Grossmont Union High School District

GROSSMONT KITCHEN AND WEIGHT ROOM MULTI PRIME CN-2982 THROUGH CN-2991

Addendum No. 4

ADDENDUM NO. 3

### **REVISED OVERALL SITE DEMOLITION PLAN**

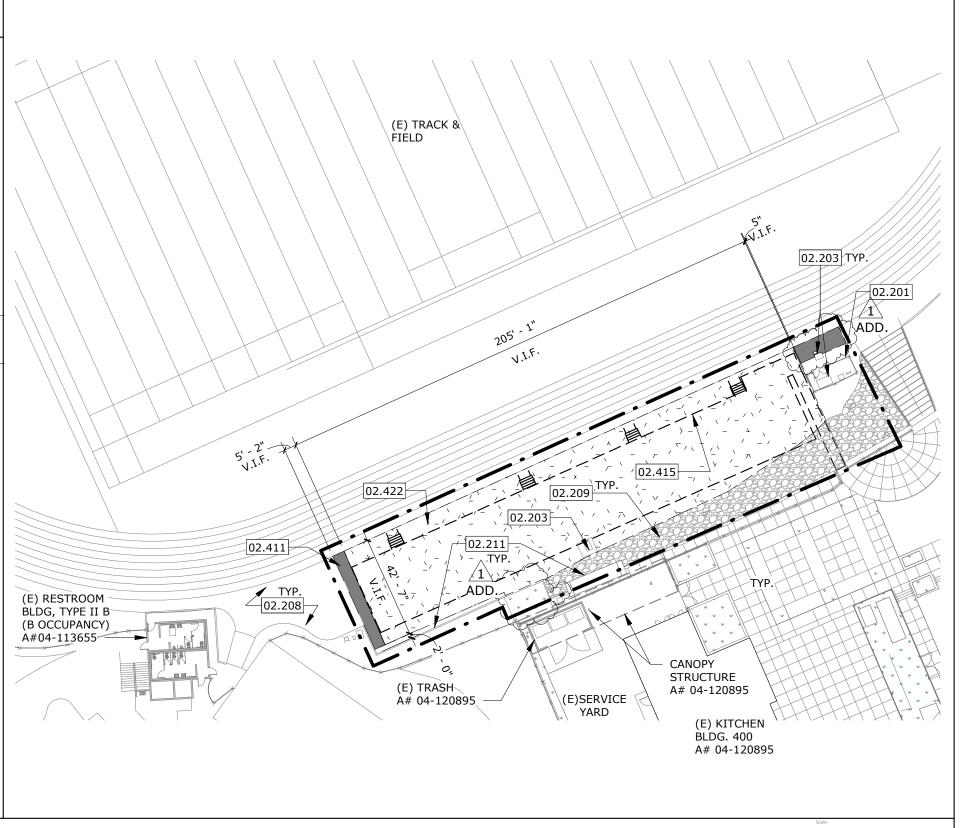
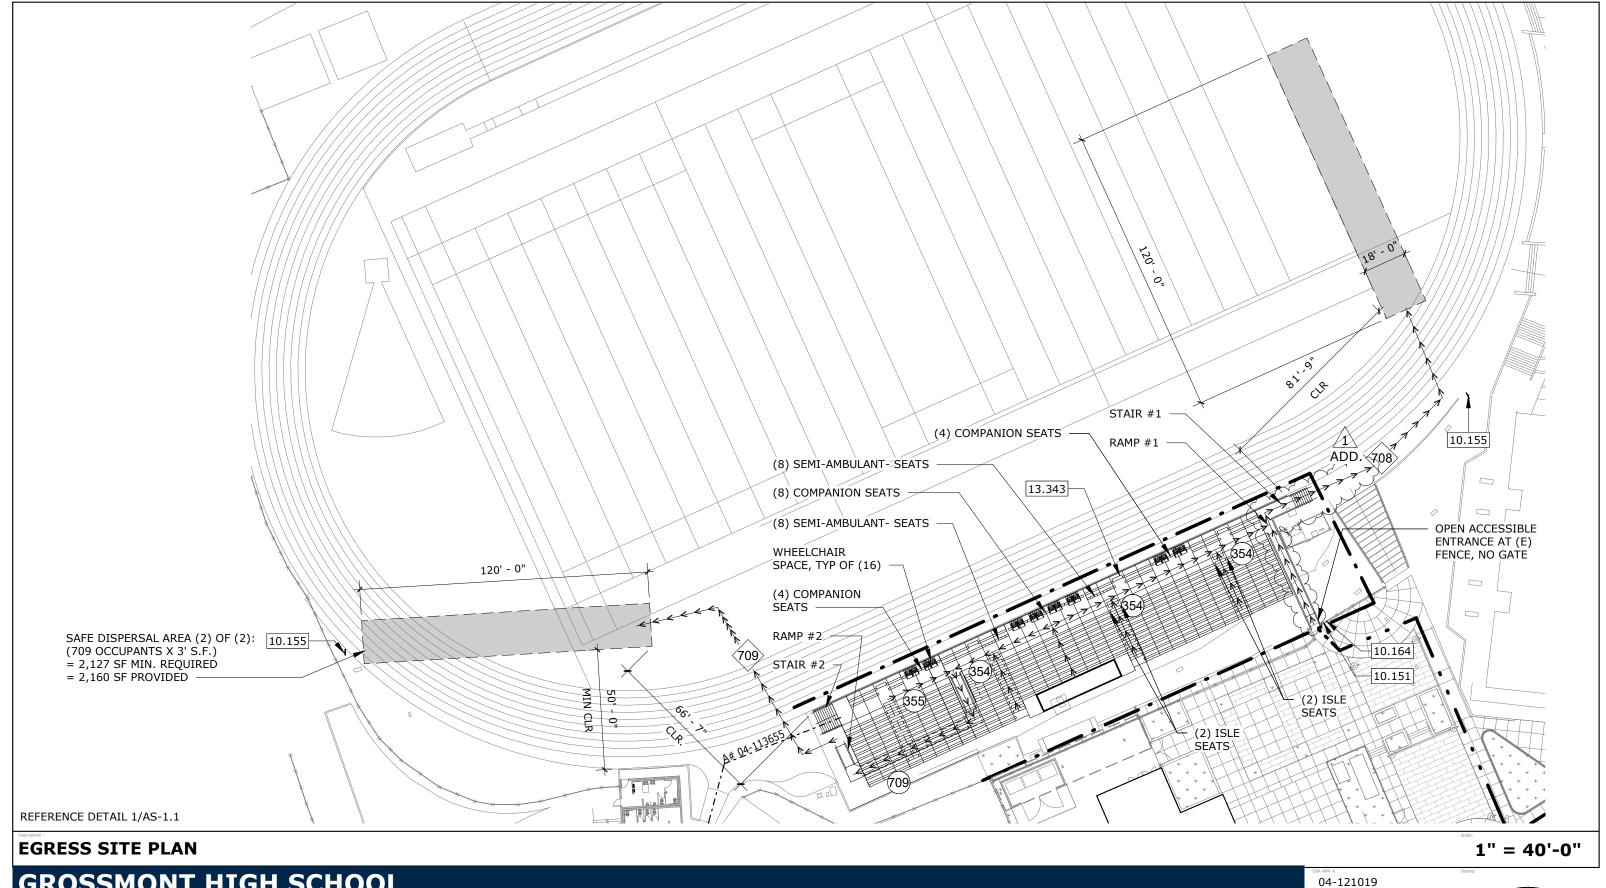
0	
Item No. 1.1	Reference Sheet AS-1.0- Overall Site Demolition Plan
1.1.1	Modified Demolition Site plan to show existing landscaping to remain per attached ASK-1.1.
